GARMONS ESTATES SUBDIVISION

Engineering Comments: FINAL PLAT COMMENTS (should be addressed prior to submitting the FINAL PLAT for review and/or signature by the City Engineer):

APPLICATION NUMBER 3 DATE March 19, 2020

DETAIL SITE PLAN

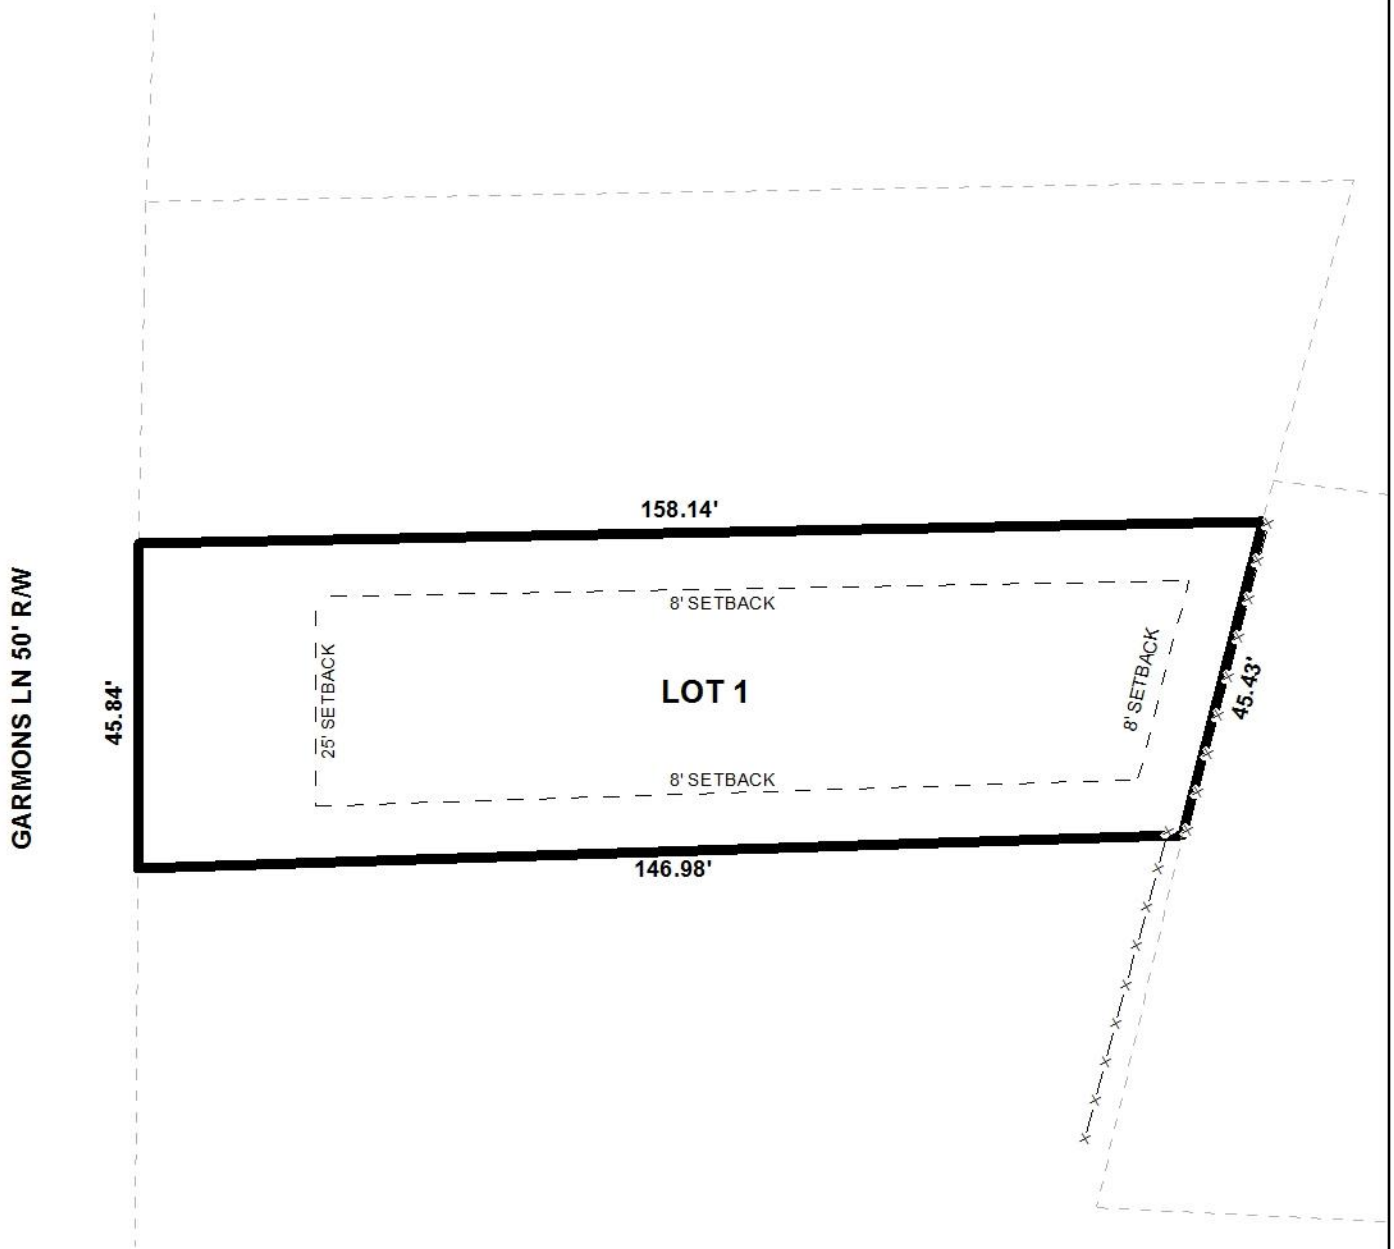
The site has frontage on Garmons Lane, which is a minor street, with curb and gutter, and with a compliant 50' right-of-way. Therefore, no frontage dedication would be required. The preliminary plat indicates the front 25' minimum building setback line as part of boxed building setback lines. The plat should be revised to illustrate the front 25' minimum building setback as spanning the entire width of the lot frontage. The plat indicates 8' minimum side yard building

setbacks on both sides of the lot. As the lot is 45.84' wide, the actual minimum building setback would be 6.5' on one side, with a combined side yard total of 15.3' required. Additionally, the side yard setbacks illustrated on the plat could be confusing when submitting for building permits, so the plat should be revised to remove the side yard setbacks.

The lot is labeled with its size in both square feet and acres, and this should be retained on the Final Plat, or a table should be furnished on the Final Plat providing the same information.

- 1) revision of the plat to illustrate the 25' front minimum building setback line spanning the entire width of the lot;
- 2) retention of the lot size label in both square feet and acres on the Final Plat, or the furnishing of a table on the Final Plat providing the same information;
